Recall - Brake Light Relay Replacement

V70 (01-)/V70 XC (01-)
2002

Recall Campaign No.131 Brake Light Relay

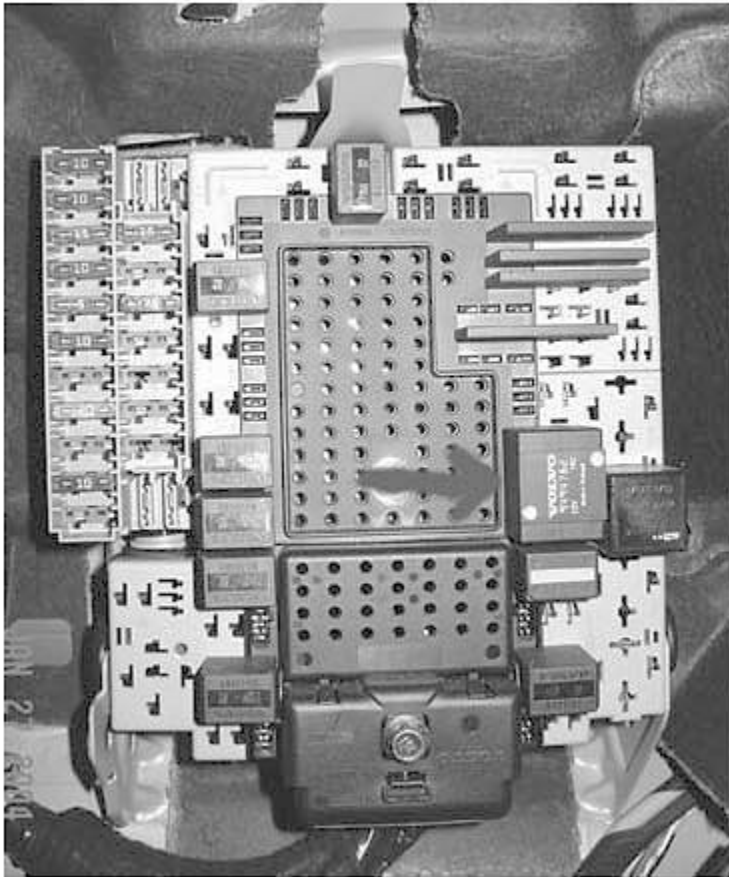
Remove the left rear cargo compartment trim panel in order to access the Rear Electronic Module. With the ignition off, REMOVE the RELAY installed in position RMI 5 and position RMI 6 in the REM, which controls both brake lights and the rear fog light as shown.

Install TWO new relays, part number 8651661 in the REM positions RMI 5 and RMI 6 as shown.
